Southeast Alaska Conservation Council

RE: Kensington Gold Mine POA1 draft SEIS Comments

Thank you for the opportunity to submit scoping comments on the proposed amendment to the 2005 Plan of Operations (POA1) and the draft supplemental Environmental Impact Study (SEIS) for the 2004 final SEIS and Record of Decision for the Kensington Gold Mine Project. The agency published the Notice of Intent for this SEIS on September 23, 2019.

Figure 12c: Slate Creek (SLC) Monitoring Results 2006-2017, Trace Chemistry

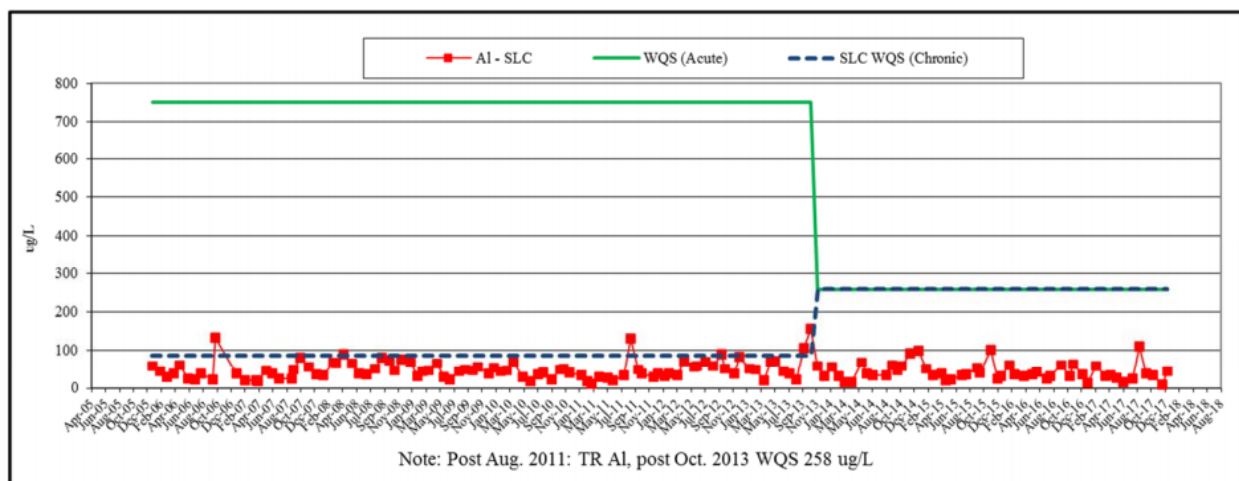
In 2013 Coeur employed an unsupported change to the aluminum criteria for Slate Creek that miraculously brought them into compliance. See below.⁸

When discussed at the Annual Meeting, SEACC was told that this represented an Upper Tolerance Limit (UTL). UTL's are not meant to be a standard or criteria. UTL's are a statistical analysis of the confidence that levels of contamination can be detected above background at a particular sample site. It does not set background levels or establish new criterion. It is also not a natural conditions determination or a site specific criteria. There is no justification to change the 86 mg/L chronic level for aluminum. Coeur Alaska should comply with published aluminum criteria and work to resolve the exceedances.
